CHANGE/ERRATA INFORMATION

ISSUE NO: 2 10/93

Title: 1722A/1752A Service
Part Number: 732156
Print Date: September 1984
Rev. & Date: 2, 3/92

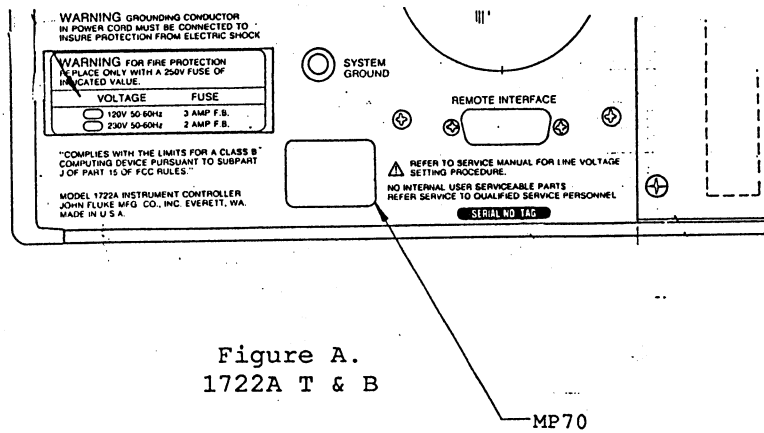
CHANGE #1 - 45050

On page 4-7, Table 4-3,

CHANGE: H5|WASHER, FLAT, STL, .149, .375, .031|110270|COMMERCIAL|9
 TO: H5|WASHER, FLAT, STL, .149, .375, .031|110270|COMMERCIAL|18

Figure C.
1722A-1009

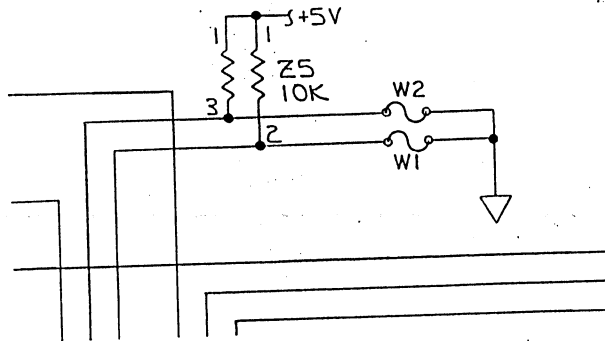
On page 5-48, Figure 5-9, delete SW2, add W1 and W2 as shown in Figure C.

DELETE: SW2|SWITCH, DIP, SPST, 4 POS|408559|00779|435166-2|1

ADD: W1,2|WIRE, JUMPER, TEF, 22AWG, WHIT, .300
 |528257|60386|528257|2

Figure D.

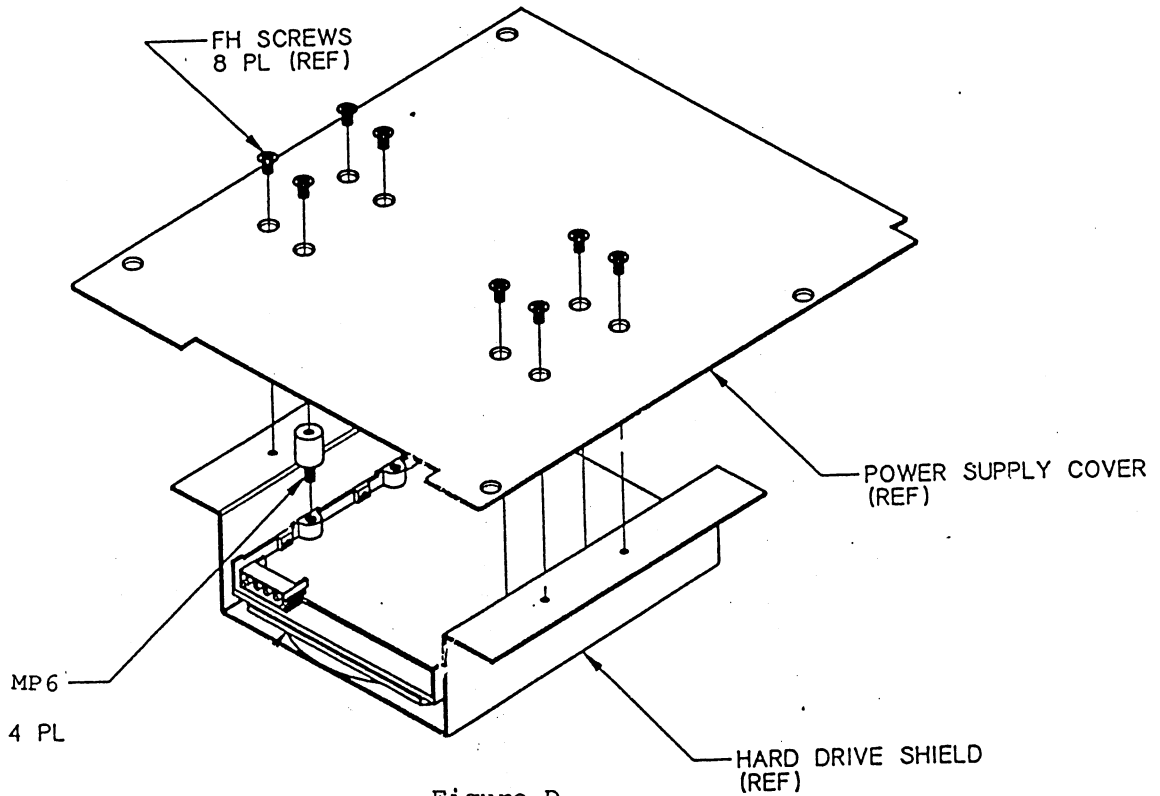
On page 4-50, Figure 4-16, add MP6 as shown in Figure D.

ADD: MP6 | MOUNT, SHOCK, M-F, RUBBER, 6-32, .500, .250 | 928077 | 5P059 | 1
